McCULLOCH

SERVICE BULLETIN #1046

SUBJECT: SHOCK ABSORBER FOR CHOKE BUTTON

MODEL MAC D30 and D36 DATE 12/29/58

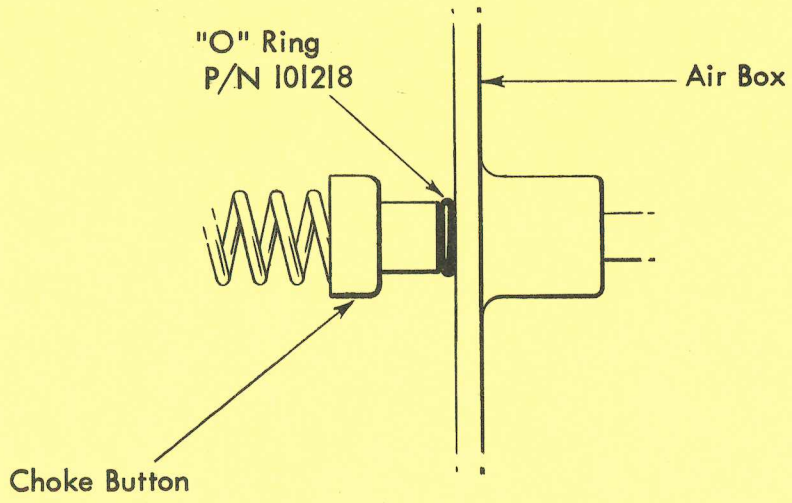
To prevent breakage of the choke button due to shock in extreme cold weather, install an "O" ring, P/N 101218, on the choke button as shown, to absorb the shock when choke button is released.
